ALTERNATIVE COMPLIANCE REVIEW COMMITTEE AGENDA

1. ACRC-2023-00002 – 1601 South Boulevard

ALTERNATIVE COMPLIANCE REVIEW COMMITTEE STAFF REPORT

Date: November 2, 2023
Item Number: ACRC-2023-00002
Applicant: Mitchell Drazkowski
Location: 1601 South Boulevard
Request: Alternative compliance from Section 15.2, Stepback and 15.3.3, Parking Structure Design
Date Application Received: October 5, 2023

PROPOSED SITE/ 1ST FLOOR PLAN

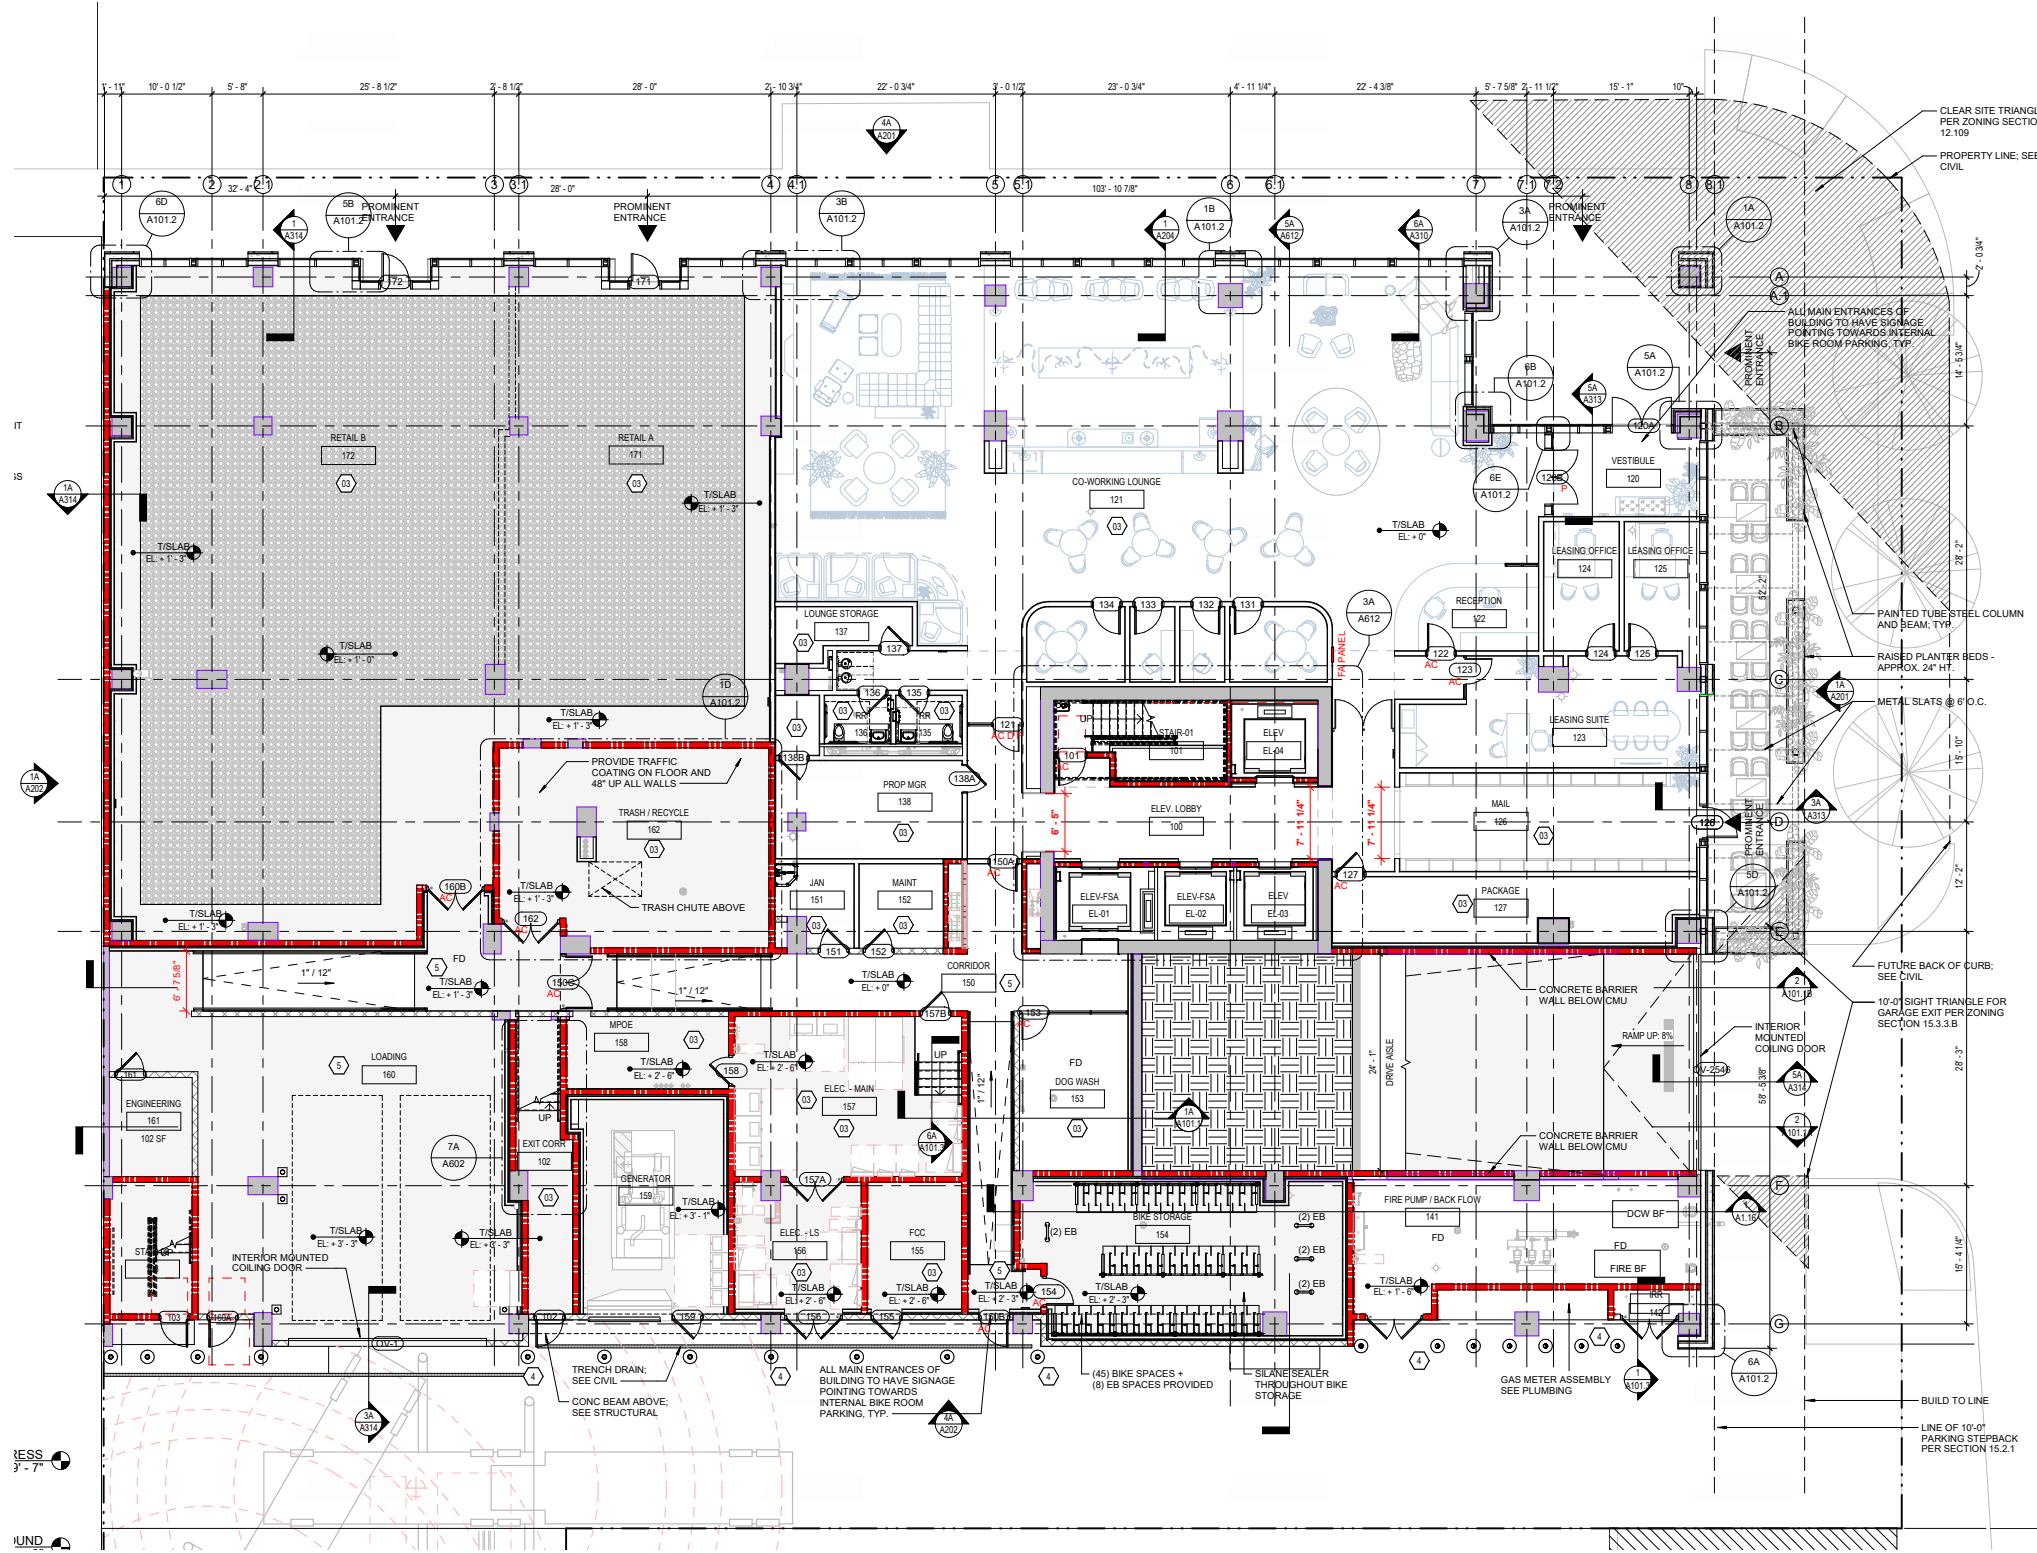
In lieu of providing the required 10' stepback for parking above, the applicant is proposing:

- An additional 10' setback for the entire building facade along Park Avenue with an unenclosed usable outdoor space for users of the building within the additional 10' setback

Staff recommends denial of the request. The TOD requirements are intended to step back the building's massing and the parking structure façade along the Other Primary frontage. The proposed open space area does not meet the intent of the TOD Ordinance requirements.

PROPOSED ELEVATIONS

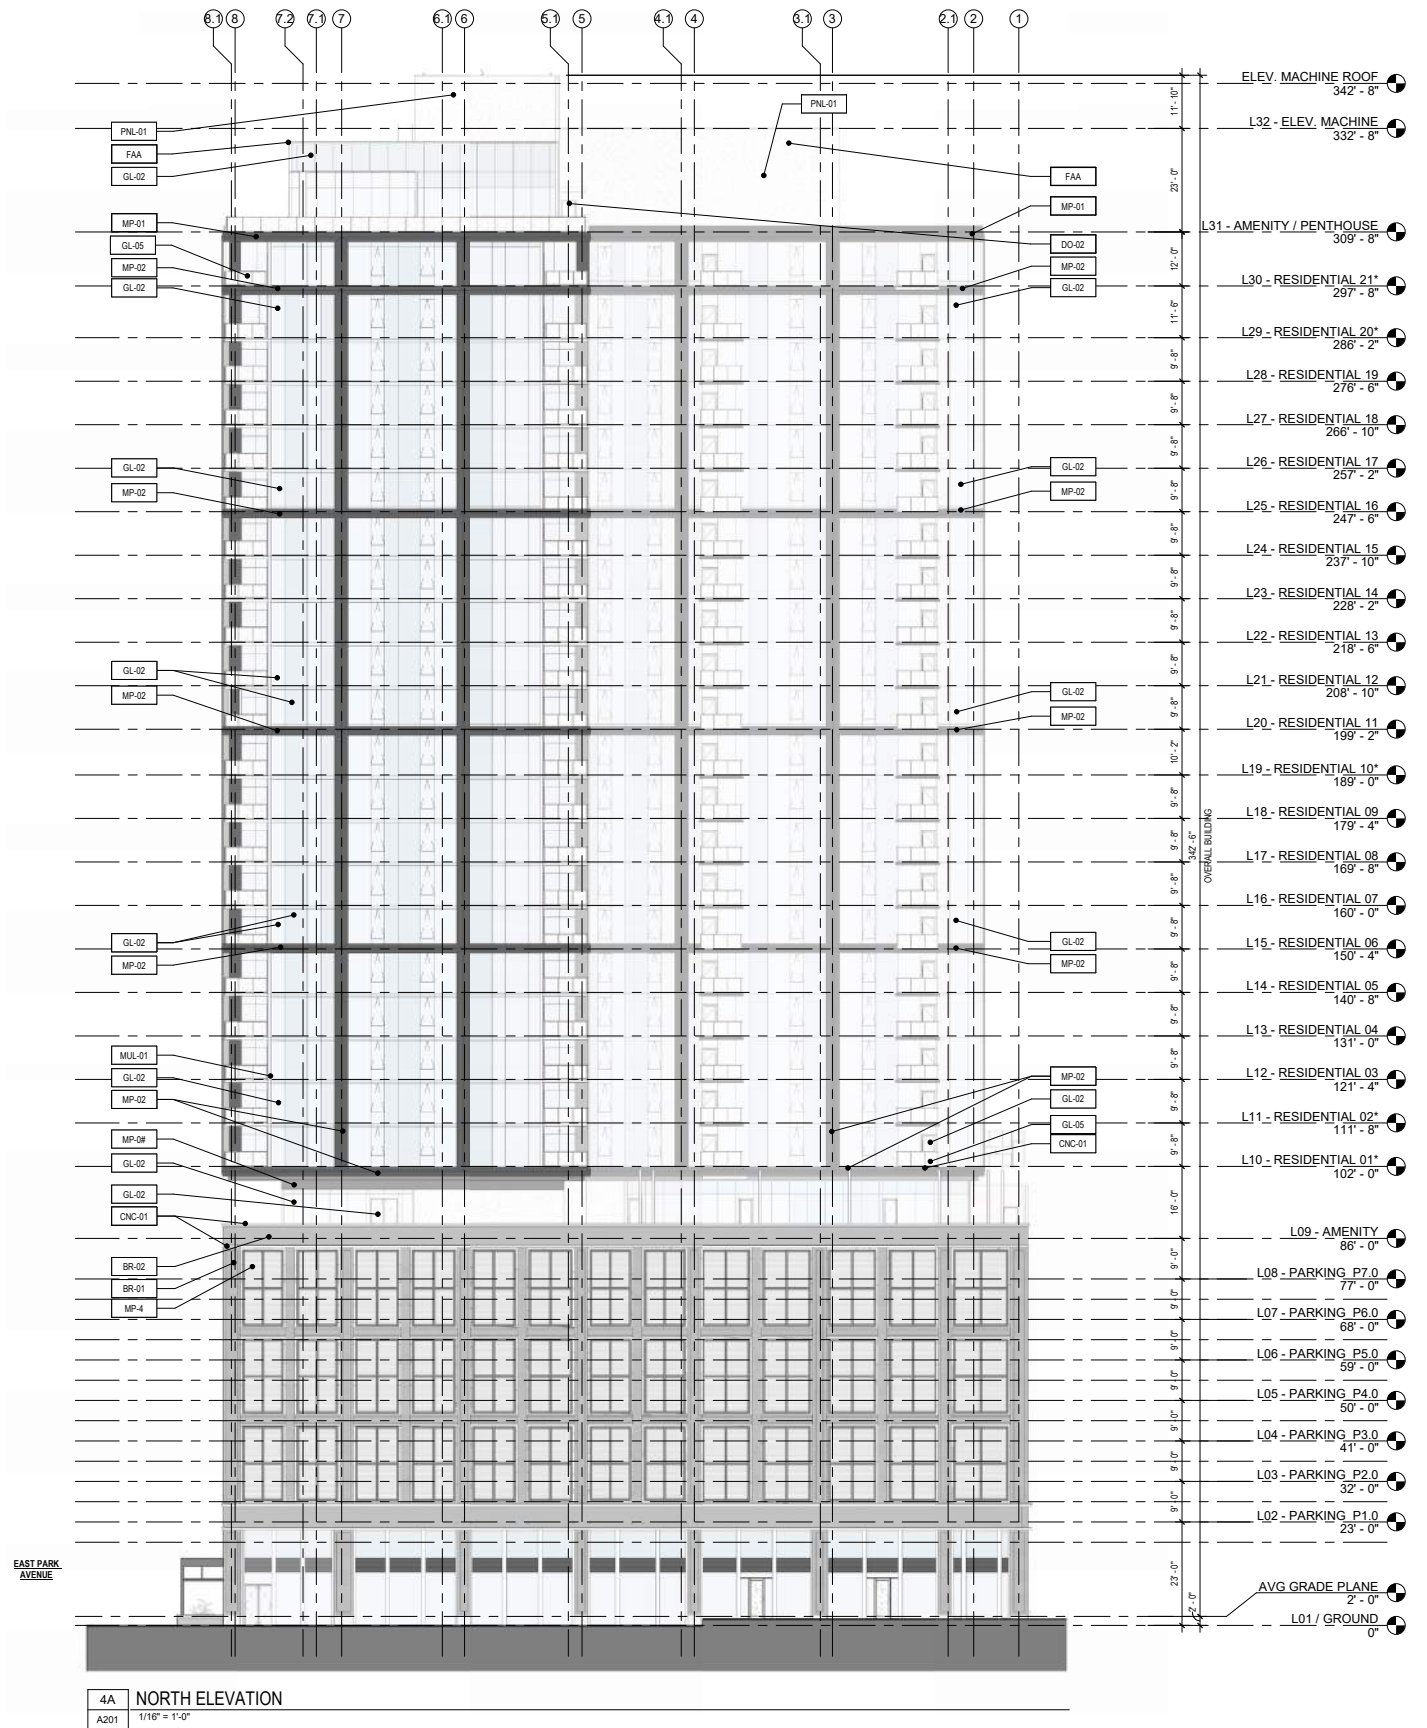
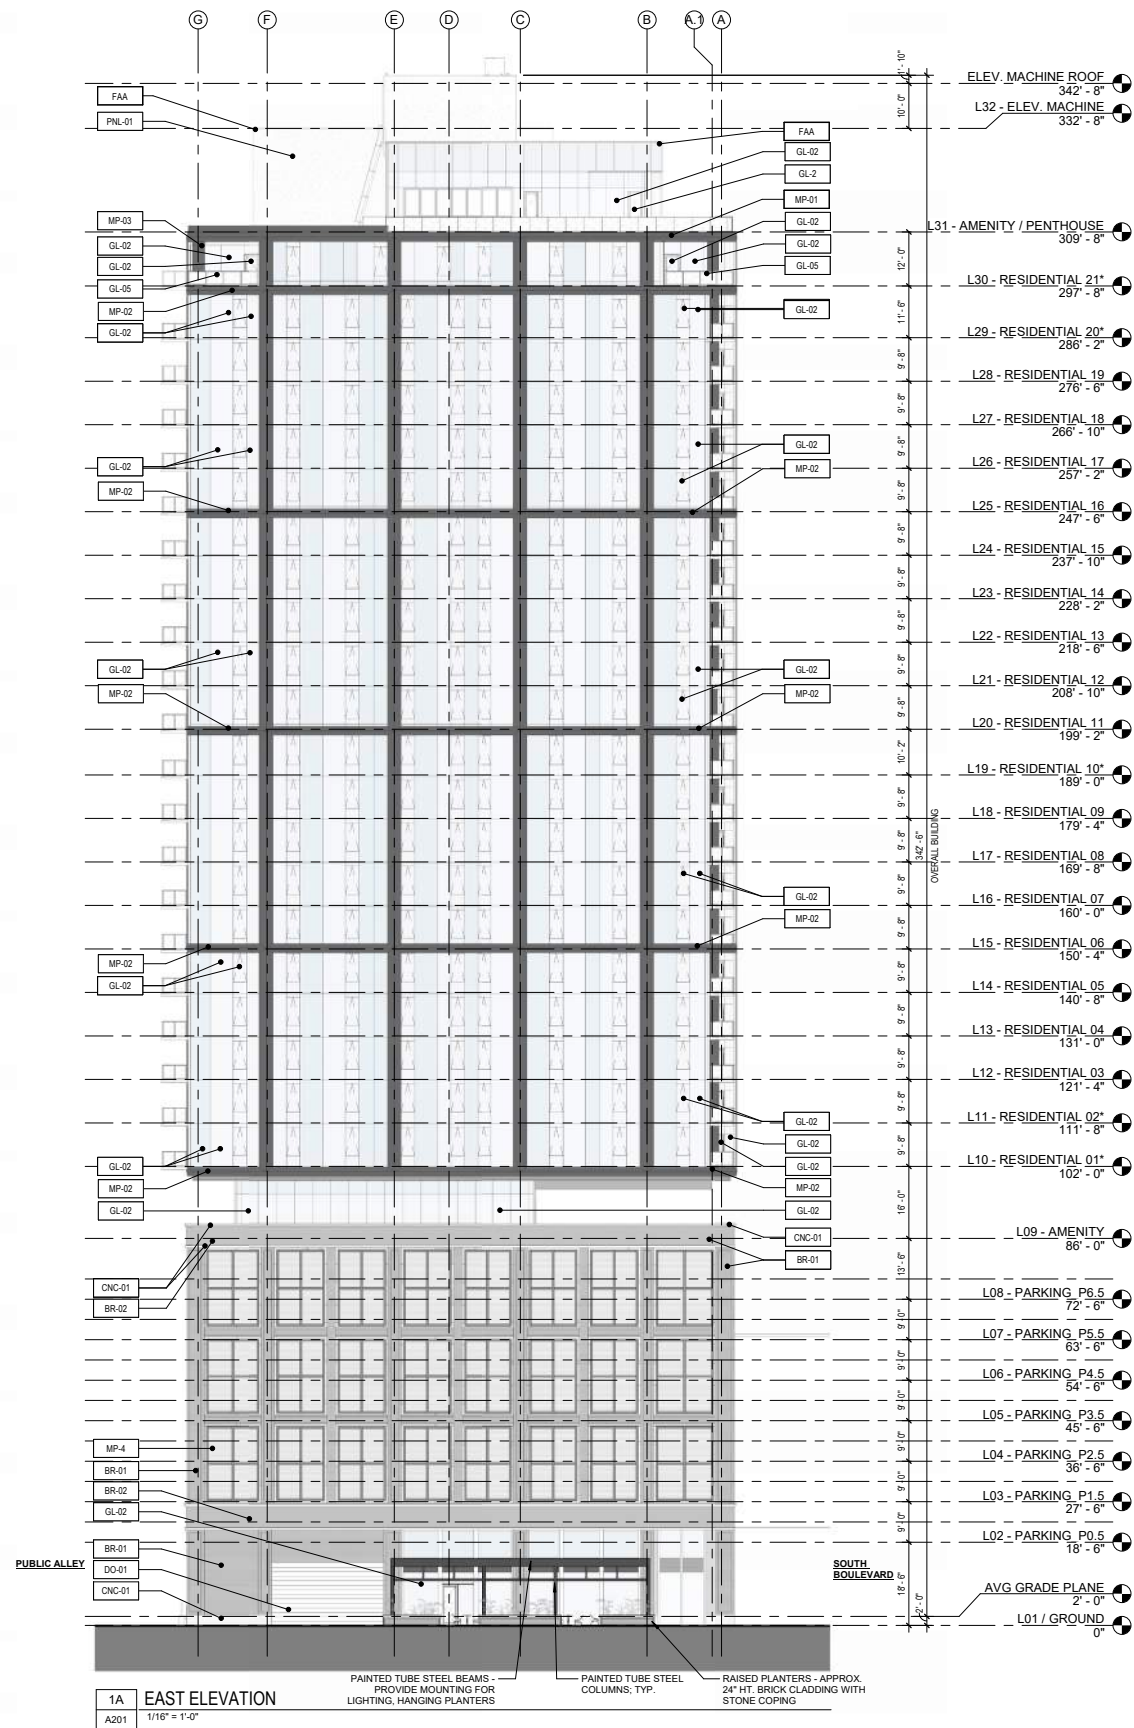
- **Building stepback standards (Sec. 15.2.1.F).** As shown in the site plan diagram, the required sight triangles greatly reduce the amount of frontage available for 1st floor space along Park Ave. Although the proposed design is not enclosed, the low planter height allow the area to extend into the sight triangles without disrupting pedestrian visibility. This allows the design to both capture more active frontage along Park Ave. than a fully enclosed design would be able to do, and more cohesively tie into the façade rhythm of the building behind.

- **Use of design elements to provide interest and break down the scale of the façade.** The proposed design is effectively an 'arcade' or 'gallery' as defined in Sec. 15.4.10 and Table 15.2, Section 2. Furthermore, it provides façade variety and articulation, which distinguishes it from the floors above.
